DEVELOPMENT ASSESSMENT REPORT		
Application No.	DA/2021/0816	
Address	141 Bedford Street NEWTOWN NSW 2042	
Proposal	Substantial demolition of the existing dwelling house, alterations and additions including a new second storey addition	
Date of Lodgement	06 September 2021	
Applicant	Habitat Planning	
Owner	Mr Craig S Kentell & Ms Melissa G Poyner	
Number of Submissions	Initial: 1	
Value of works	\$225,000.00	
Reason for determination at Planning Panel	Clause 4.6 variation - FSR exceeds 10%	
Main Issues	FSR, Period Building, Built form and Character, Landscape and Open Space, Desired Future Character	
Recommendation	Refusal	
Attachment A	Reasons for refusal	
Attachment B	Plans of proposed development	
Attachment C	Clause 4.6 Exception to Development Standards	
Attachment D	Draft Conditions of Consent should consent be granted

This report is an assessment of the application submitted to Council for substantial demolition of the existing dwelling house, alterations and additions including a new second storey addition at 141 Bedford Street Newtown.

Project: PROPOSED ALTERATIONS AND ADDITIONS AT 141 BEDFORD STREET, NEWTOWN NSW 2042
Drawing Title: PROPOSED FIRST FLOOR PLAN

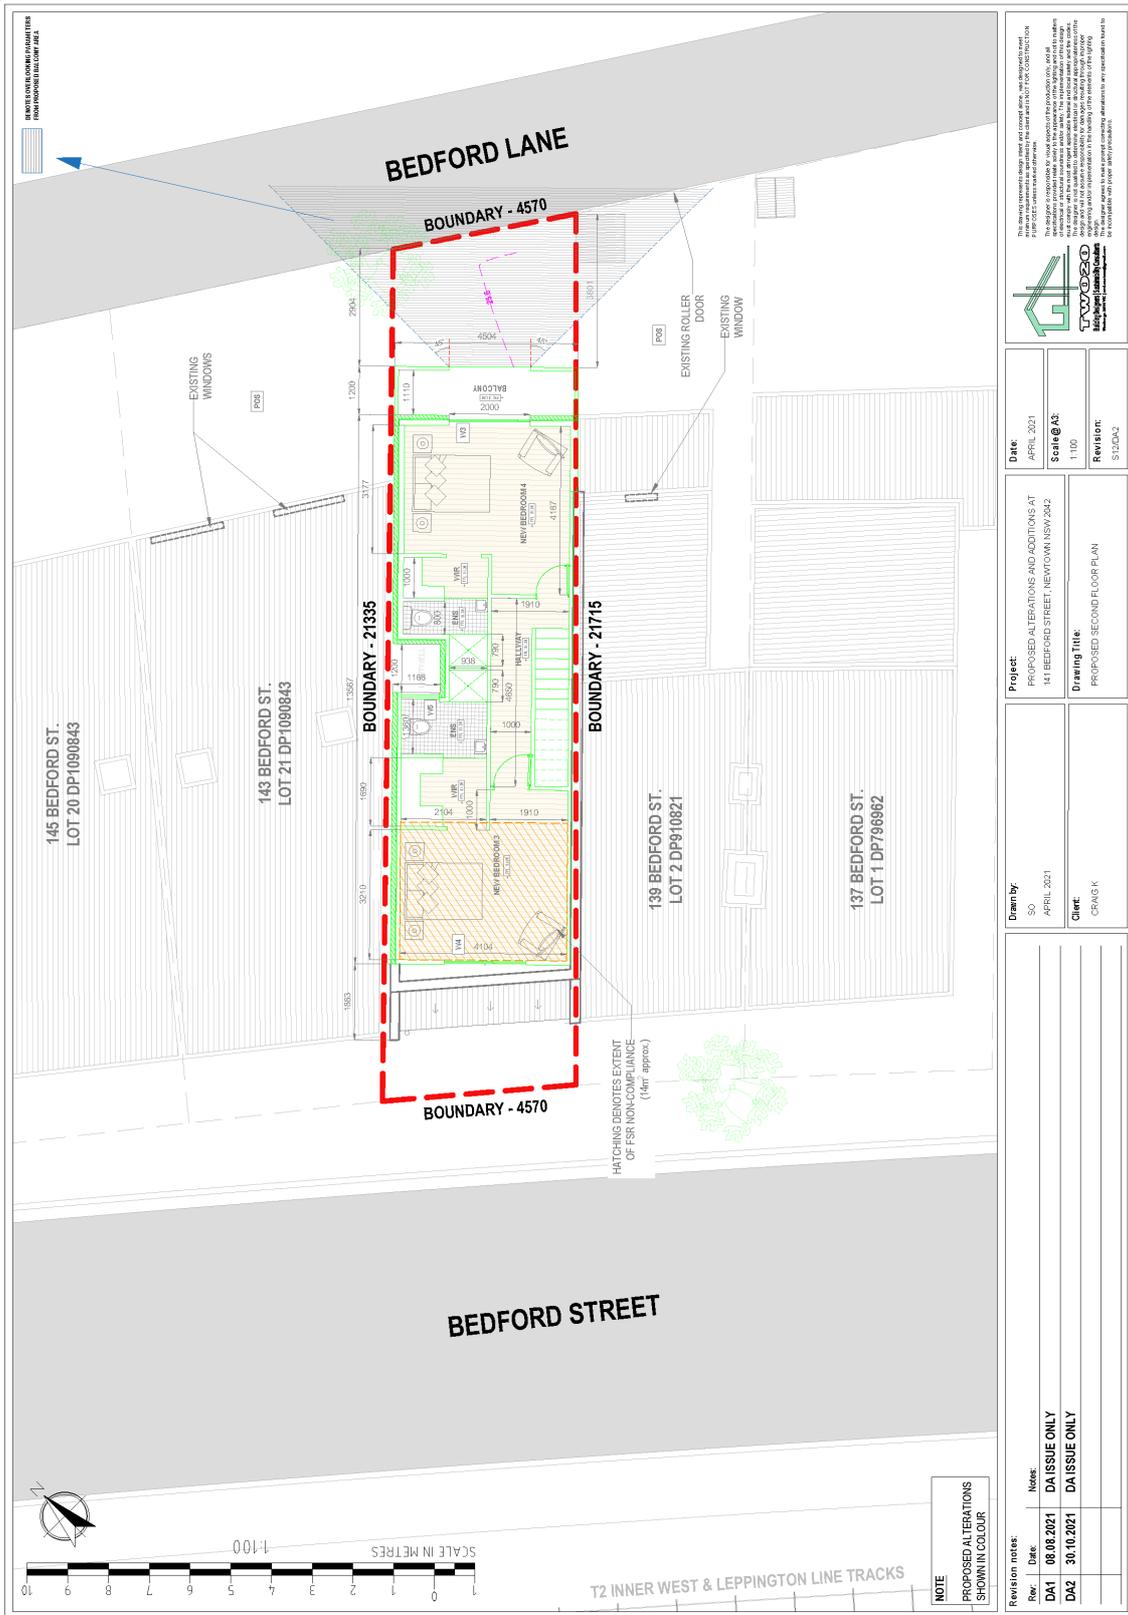
- The development results in excessive bulk for the subject and to adjoining sites, particularly due to the rear building alignment of the first and second floors that extend significantly beyond the neighbouring properties which would not comply with Part 4.1.6 of MDCP 2011 and is inconsistent with the desired future character of the area

- The development would result in a first floor rear building setback that is inconsistent with the predominant rear first floor building alignment visible from Bedford Lane resulting in adverse bulk to the public domain.

Project:	PROPOSED ALTERATIONS AND ADDITIONS AT 141 BEDFORD STREET, NEWTOWN NSW 2042
Drawing Title:	PROPOSED SECOND FLOOR PLAN

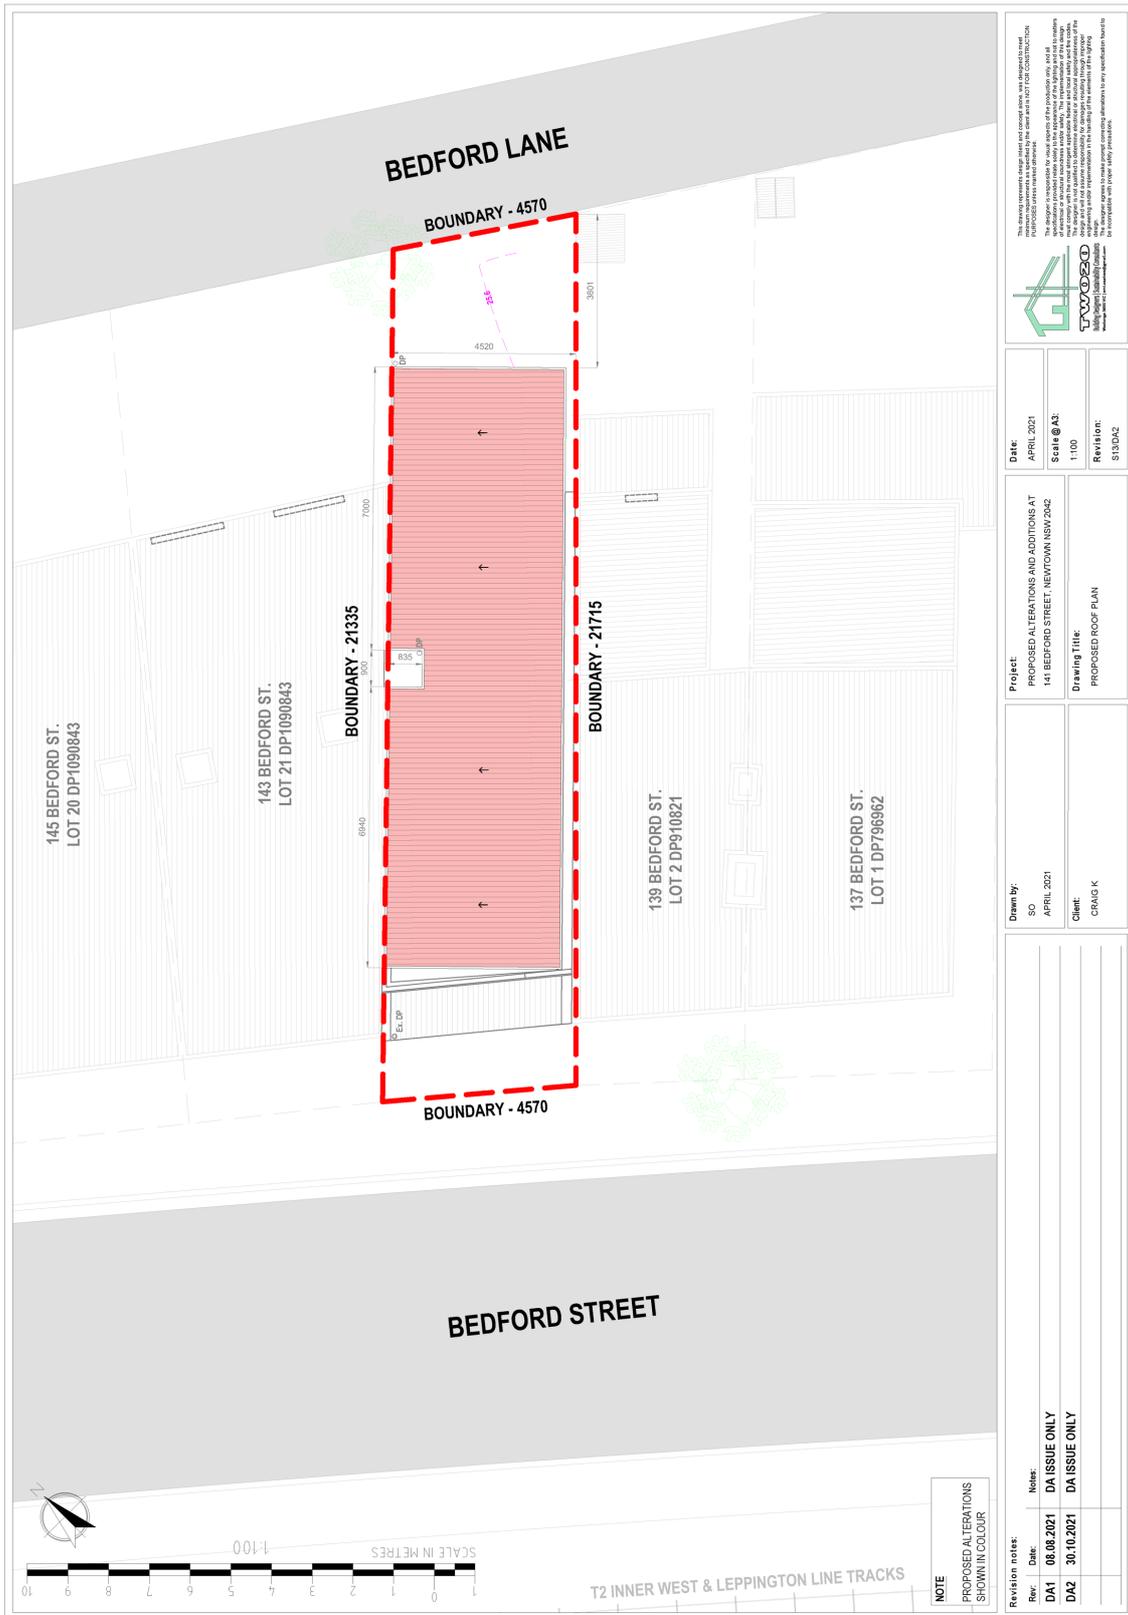
- The height, scale and bulk of the development towards the rear of the site results in adverse amenity impacts to neighbouring properties by way of visual bulk presenting to the neighbouring private open spaces and the rear of those dwellings, potentially creating adverse overshadowing. These adverse impacts are directly attributable to the additional GFA sought (beyond the prescribed standard)
